Service Bulletin No: 51-001

ATA Chapter: 51

AIRCRAFT STRUCTURE - GENERAL**DO A CHECK OF THE MATERIAL SPECIFICATION USED DURING MANUFACTURE AND, IF NECESSARY, DO A CHECK FOR CRACKS OR REPLACE THE PART****1. Planning Information****A. Effectivity**

Aileron Outboard Control-Rod - Inspection
Figure 1

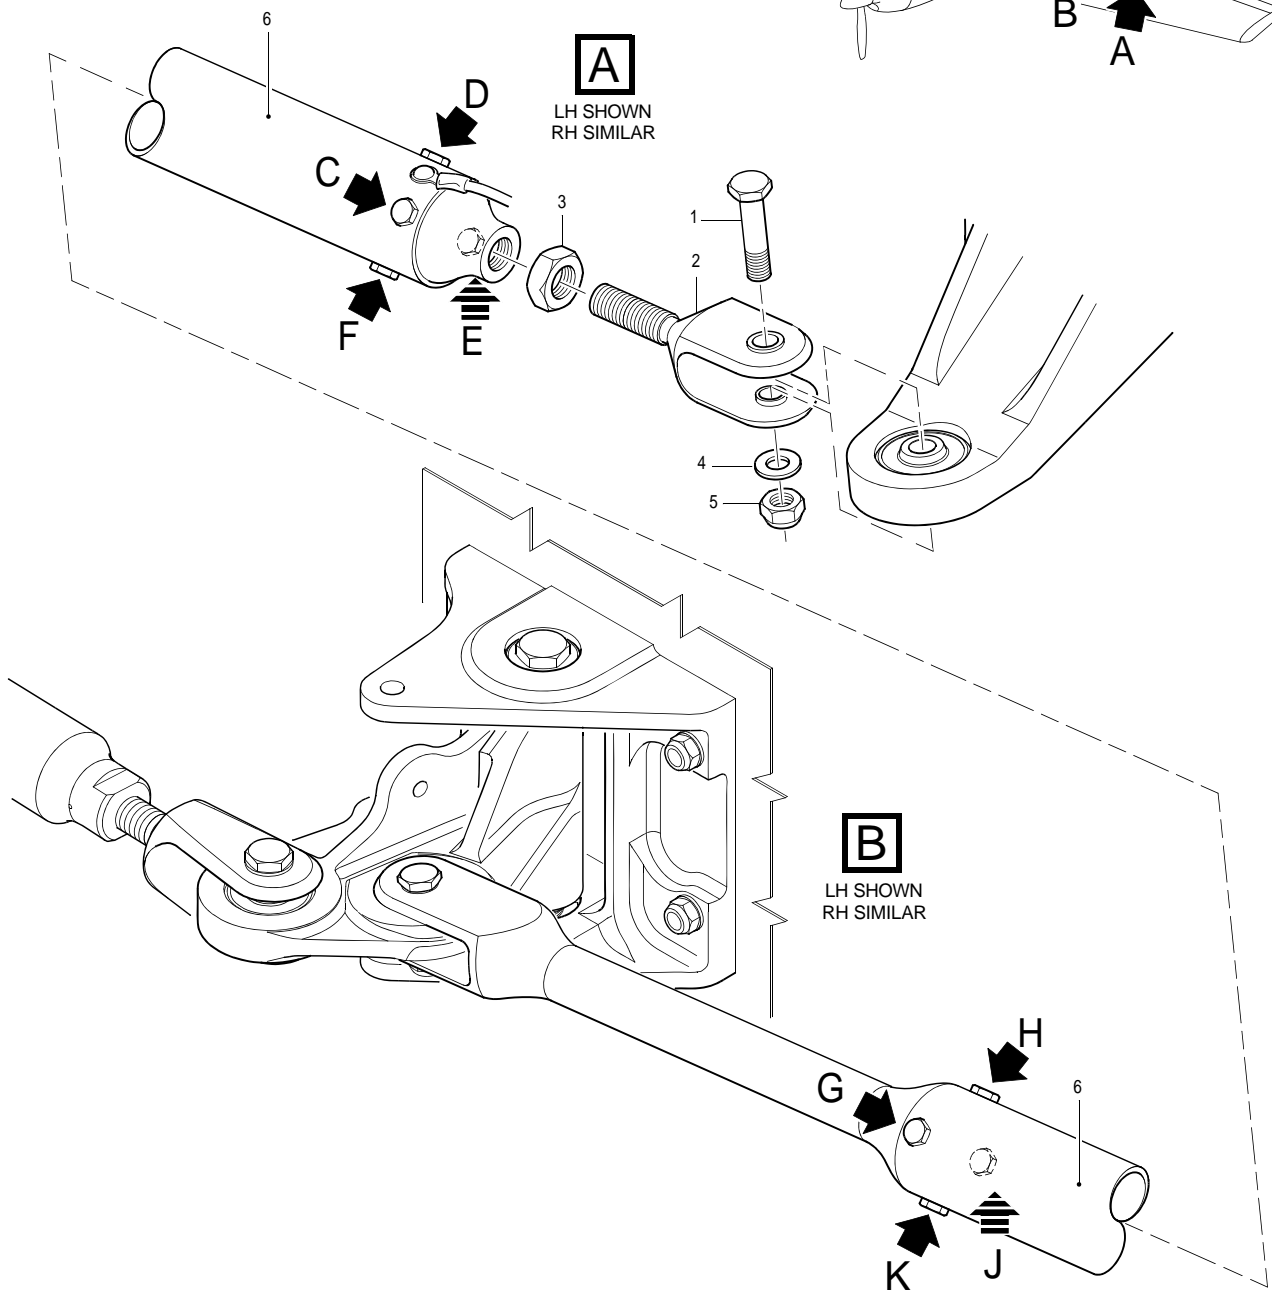
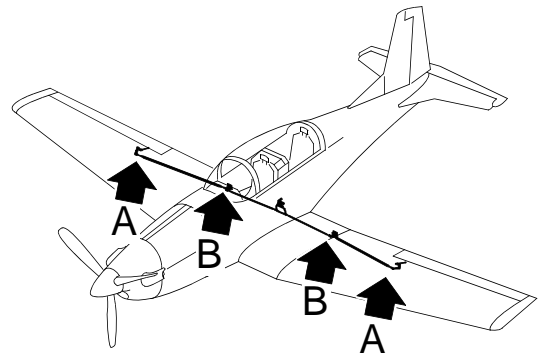
(a) Disconnect the left-aileron outboard control-rod (Ref. Fig. 1):

(b) Do an inspection for cracks (Ref. Fig. 1):

1 Put the borescope into the left aileron outboard control-rod (6). Do this through the hole for the end fitting (2).

2 Obey the manufacturer's instructions and use the borescope to examine the eight inspection areas of the left-aileron outboard control-rod (6) for cracks.

Elevator Forward Control-Rod - Inspection
Figure 3

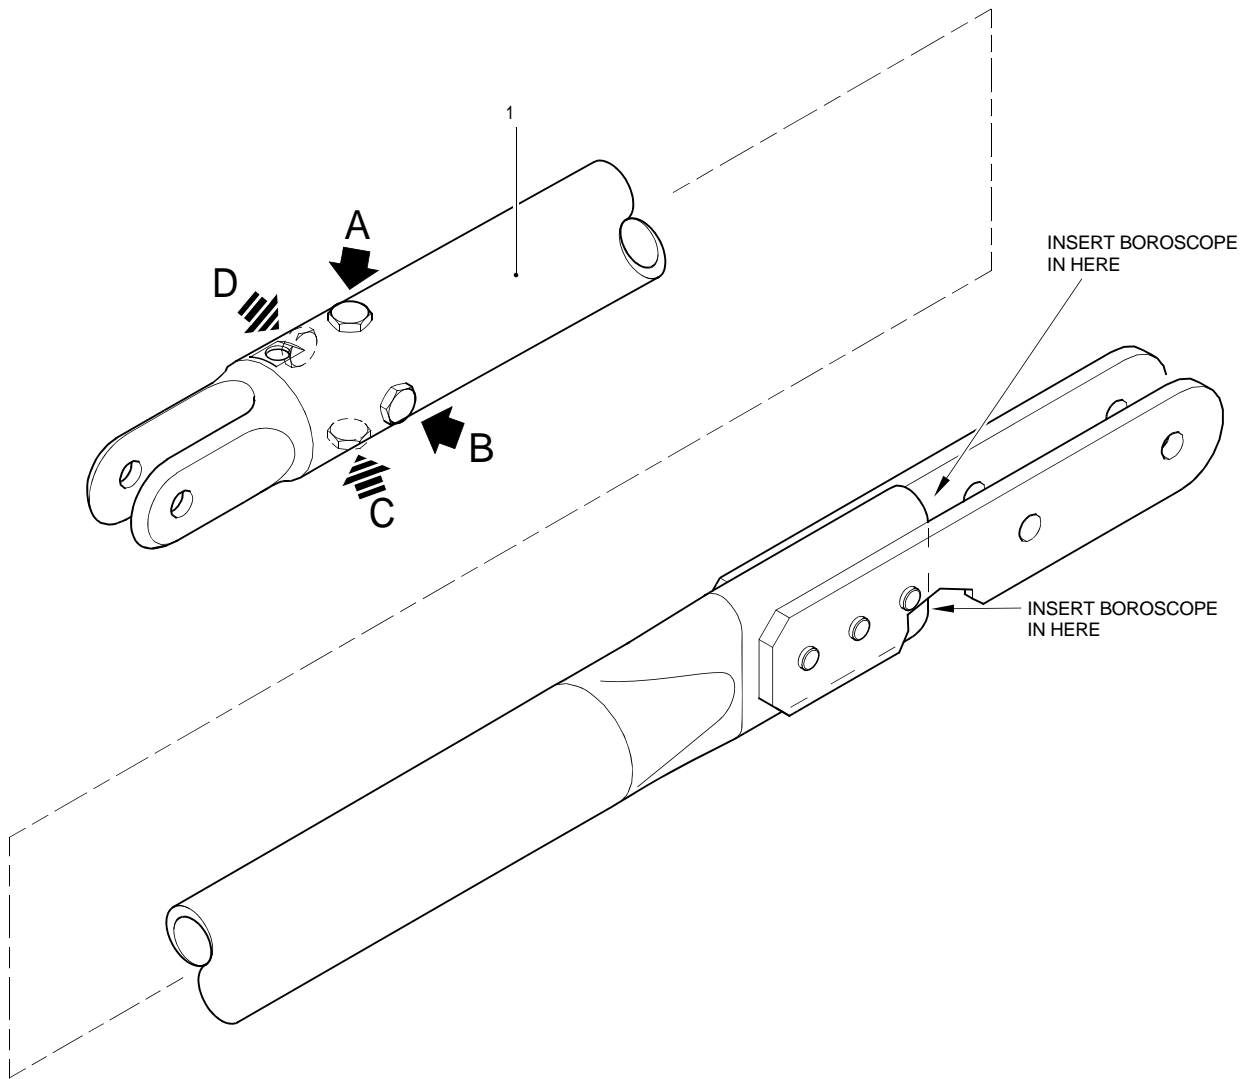
NOTE: All elevator forward control-rods have the forward clevis end made from AA2024- T351 and are therefore subject to stress corrosion.

- 1 Remove the elevator forward control-rod, (Ref. AMM, 27-30-06, Page Block 401).
- 2 Do an inspection for cracks (Ref. Fig. 3):
 - a Put the borescope into the elevator forward control-rod (1). Do this through the holes at the aft end of the elevator forward control-rod (1).
 - b Obey the manufacturer's instructions and use the borescope to examine the four inspection areas of the elevator forward control-rod (1) for cracks.
- 3 If you find cracks:
 - a You must contact Pilatus Customer Support before next flight. The address is:

Identification of the Elevator Center Control-Rod
Figure 5, Sheet 1 of 2

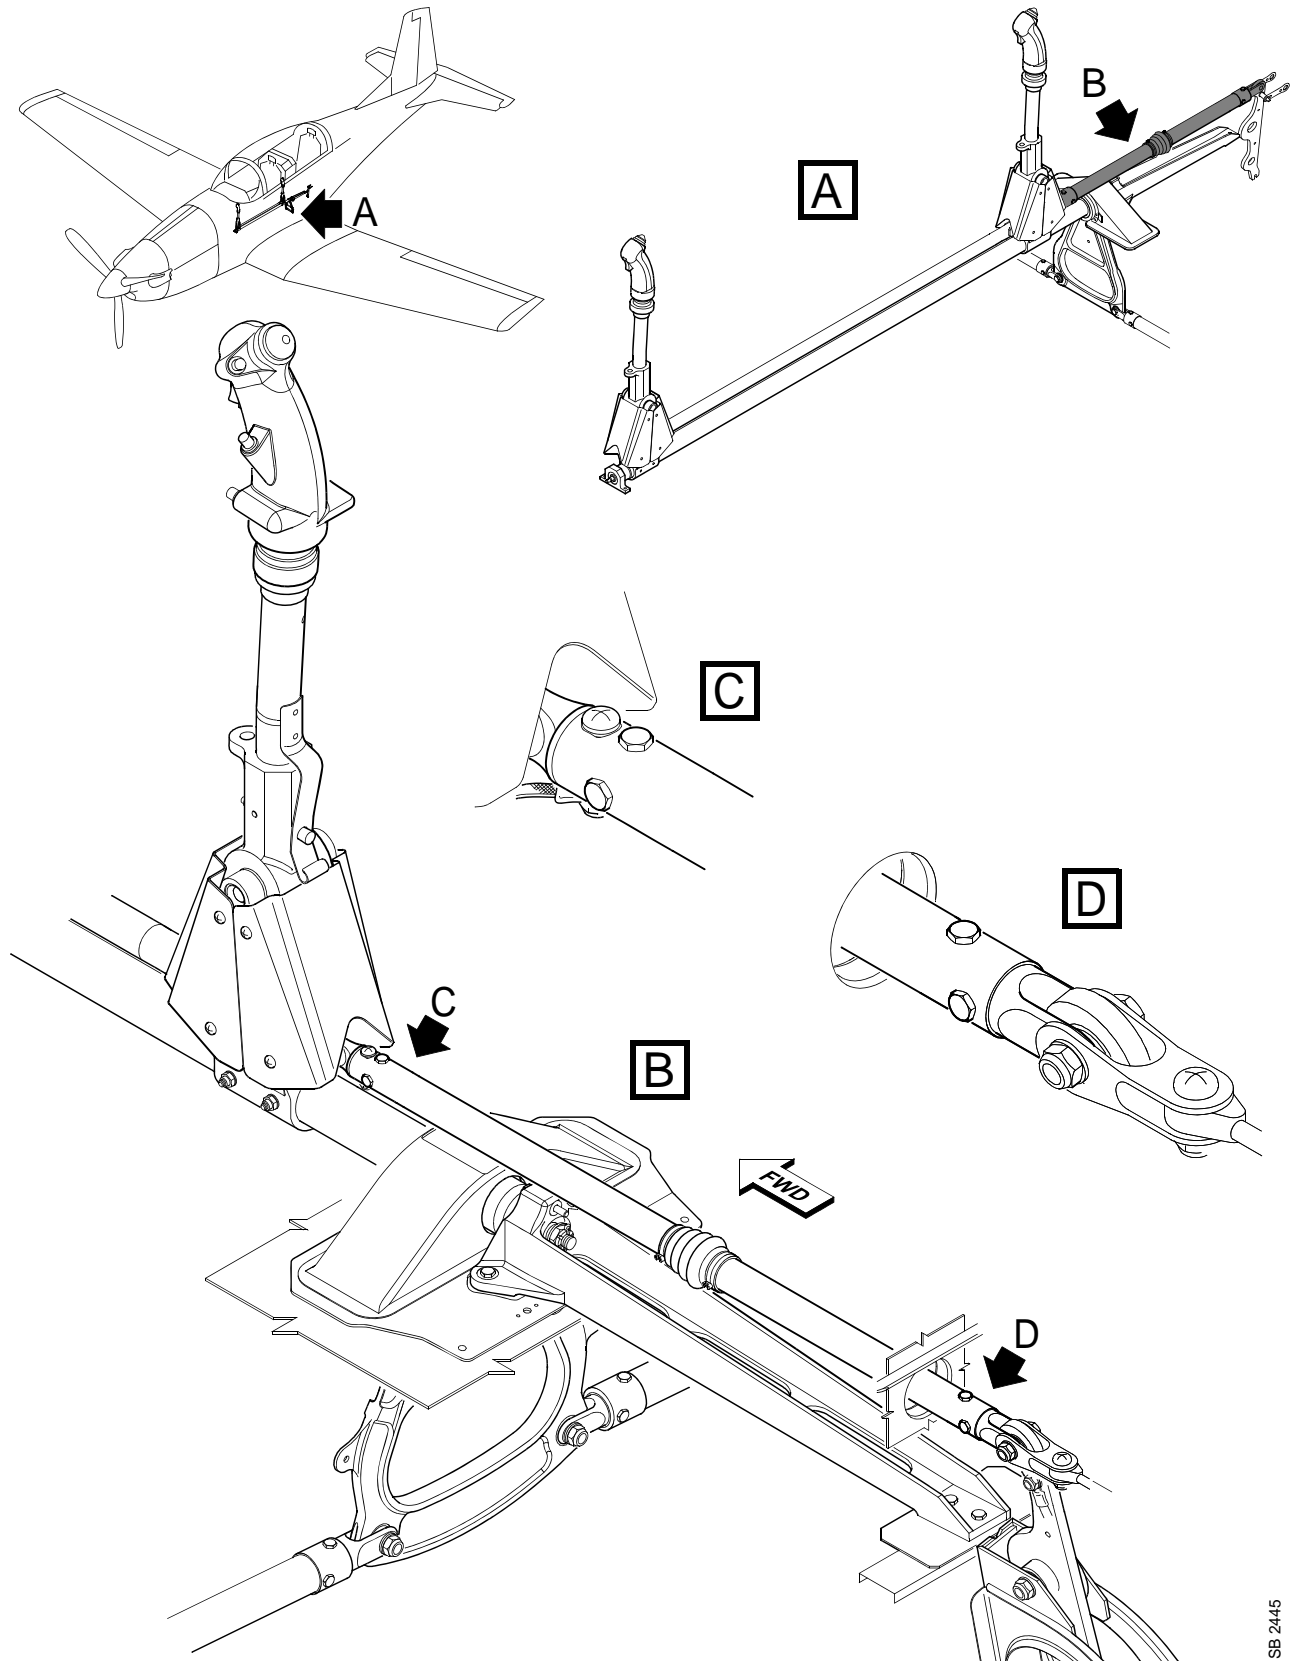
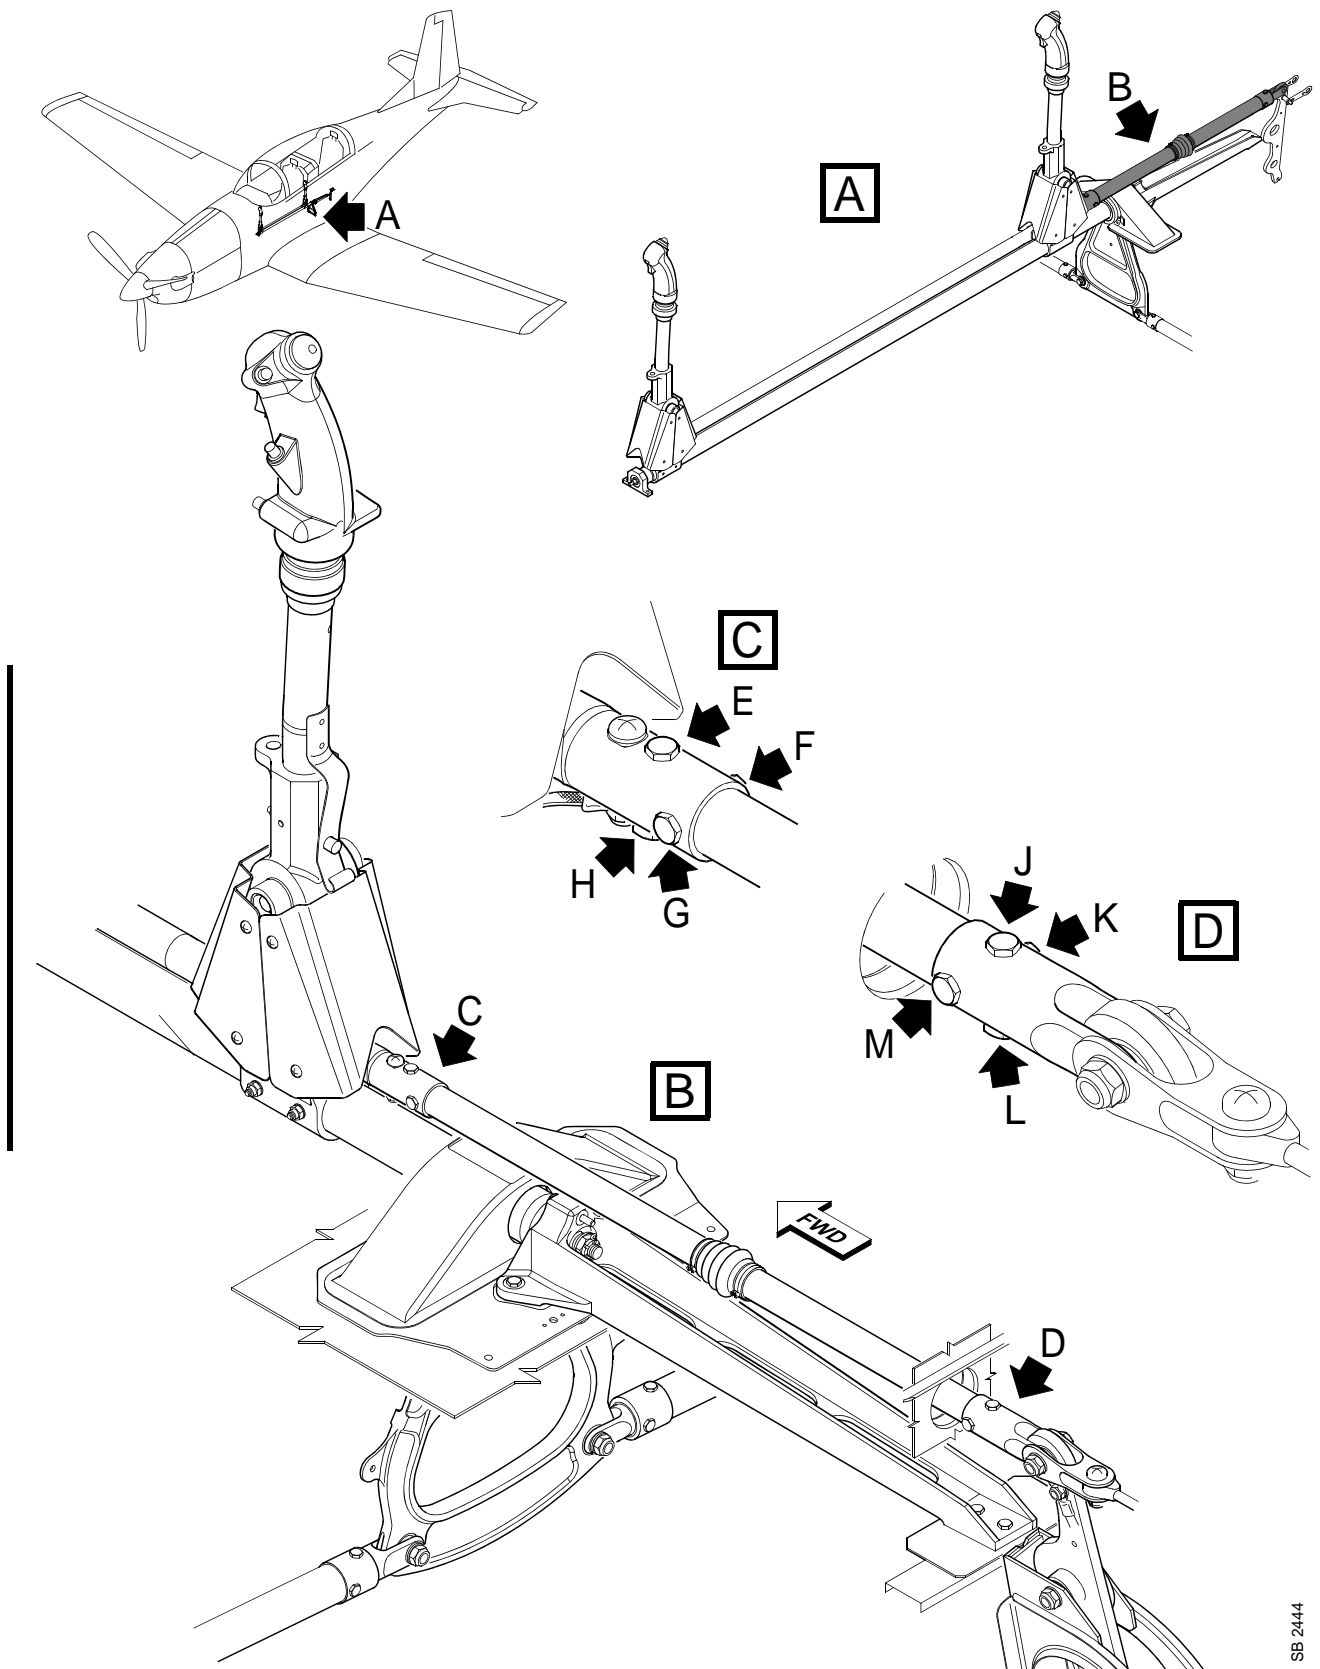
NOTE: All elevator center control-rods (P/N 116.35.07.271) have the clevis end and the rod end made from AA2024-T351 and are therefore subject to stress corrosion. Because there is no access to inspect the internal attachments for the clevis end and the rod end, the control rod will be replaced.

b If the clevis end and the rod end are installed inside the tube (Ref. Fig. 5, Sheet 1), the part number of the elevator center control-rod is 116.35.07.271. Continue this Service Bulletin from Para. 3.B.(2)(b)**2**.

c If the tube is installed inside the clevis end and the rod end (Ref. Fig. 5, Sheet 2), the part number of the elevator center control-rod is 116.35.07.345. Continue this Service Bulletin from Para. 3.B.(2)(b)**3**.

3 Do an inspection for cracks (Ref. Fig. 5):

Obey the manufacturer's instructions and use the borescope to examine the eight inspection areas of the elevator center control-rod (Ref. Fig. 5, Sheet 2) for cracks.

2 Replace the elevator center control-rod, refer to Service Bulletin 27-017.

Inspection and, if necessary, Replacement of the Shackles on the Elevator Control Cable
Figure 9, Sheet 1 of 2

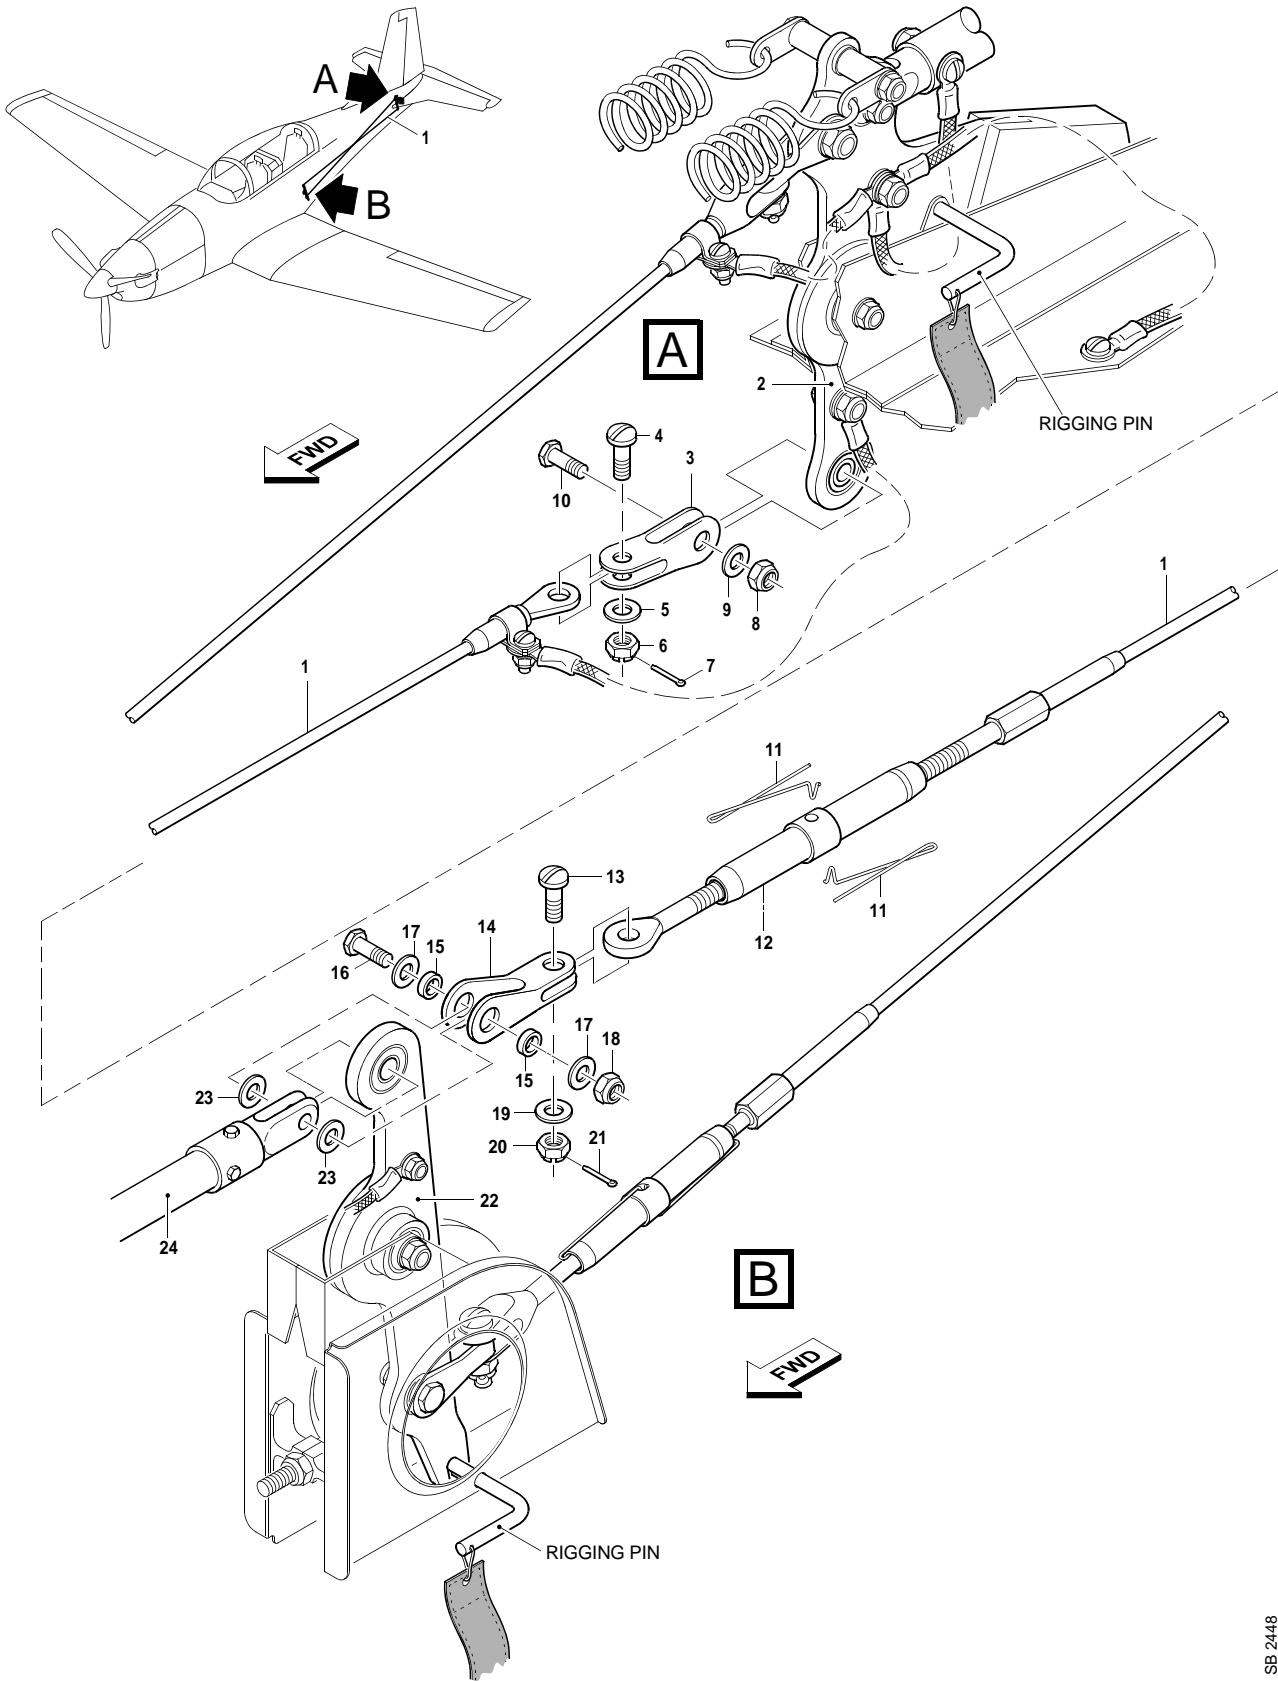
- 4 Replace the shackle (P/N 116.35.07.183) (Ref. Fig. 9):
 - a Make sure that the elevator is in the neutral position.
 - b Install rigging pins (P/Ns 110.85.07.050) at the front and rear levers (22 and 2).

- 5** Replace the shackle (P/N 116.35.07.092) (Ref. Fig. 9):
- NOTE:** Step 3.B.(2)(d)**5** is only applicable to shackles (P/N 116.35.07.092) made from AA2024-T351.

- a** Remove, and discard, the cotter pin (7).
- b** Remove the nut (6), the washer (5) and the bolt (4) that connect the shackle (3) (P/N P/N 116.35.07.092) to the control cable (1).

Center Tank Support-Bracket - Inspection
Figure 10

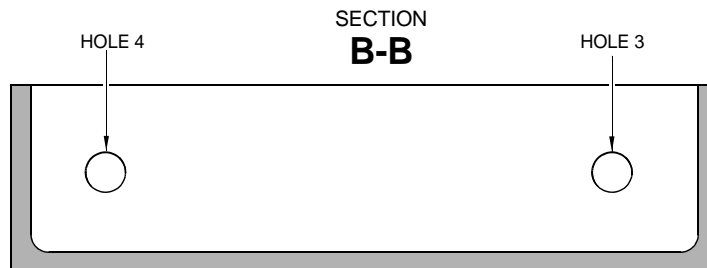
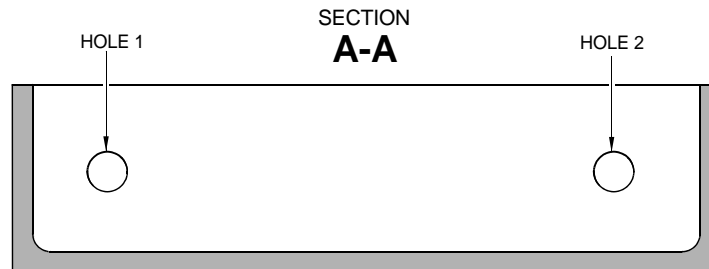
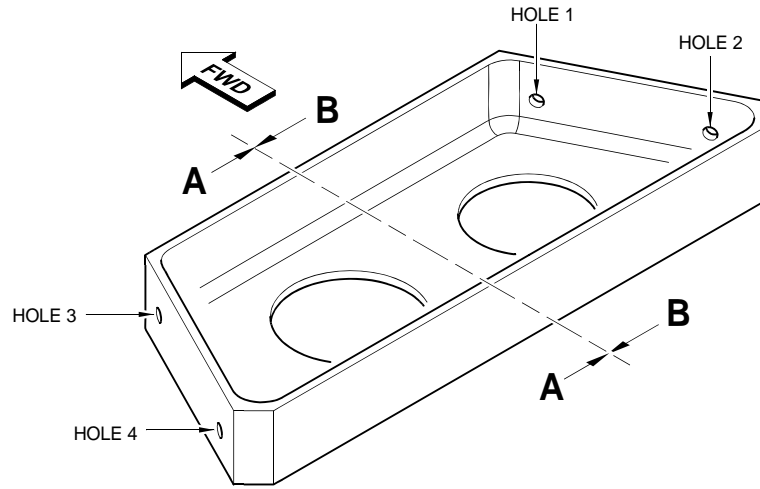
1 Use the absorbent paper (Material No. P02-031) made moist with the solvent (Material No. P01-010) and remove the dirt and grease from the inspection areas of the center tank support-bracket (P/N 112.35.07.796).
